## Los Angeles Regional Water Quality Control Board

### **COMMENTS ON WEST DRAINAGE CHANNEL MASTER PLAN - SUNSHINE CANYON LANDFILL, SYLMAR, CALIFORNIA (FILE NO. 58-076, ORDER NO. R4-2008-0088, WQID NO. 4B190329001)**

# COUNTY OF LOS ANGELES

### **WEST DRAINAGE CHANNEL MASTER PLAN SURFACE WATER DRAINAGE ANALYSIS REPORT SUNSHINE CANYON CITY/COUNTY LANDFILL**

10/2014			SUNSHINE CANYON LANDFILL	FIGURE
			WESTERN DRAINAGE MASTER PLAN	1
			SYLMAR, CALIFORNIA	PROJECT NO.
			DRAINAGE MAP	2014-0084

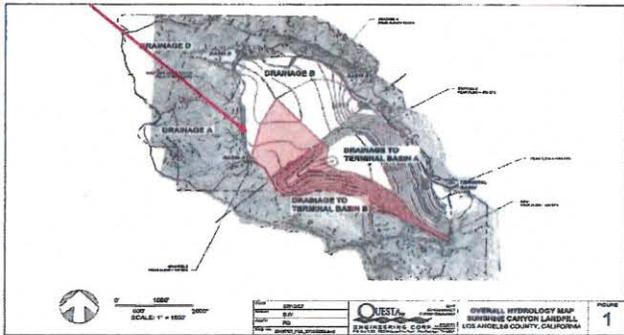
- The Drainage Map, Figure 1, provided under Attachment D shall include adequate topography, clarity, and resolution to depict watershed delineation. Each subarea shall be clearly labeled, and subarea collection points shall be shown. The Time of Concentration path from the most remote point of the subarea to the outlet of the subarea shall also be clearly identified. Elevations at the top and at the outlet point of each subarea shall be shown. The paths through which surface flows from the subareas are conveyed to the proposed West Drainage Channel shall also be shown. All drawings including any details, as well as any attachments must be clearly legible in order to facilitate proper review.

- The current hydrologic analysis for the West Drainage Channel is not based on the topography at the point of the landfill's built-out condition. At build-out a substantial area, shown as the area highlighted in red on the enclosed Drainage Map, will become tributary to the West Drainage Channel. Also, not included in the hydrologic analysis is the contribution from the immediate area south of the trapezoidal channel shown as the area highlighted in yellow on the enclosed Drainage Map. Both of these areas shall be included in the hydrologic analysis.
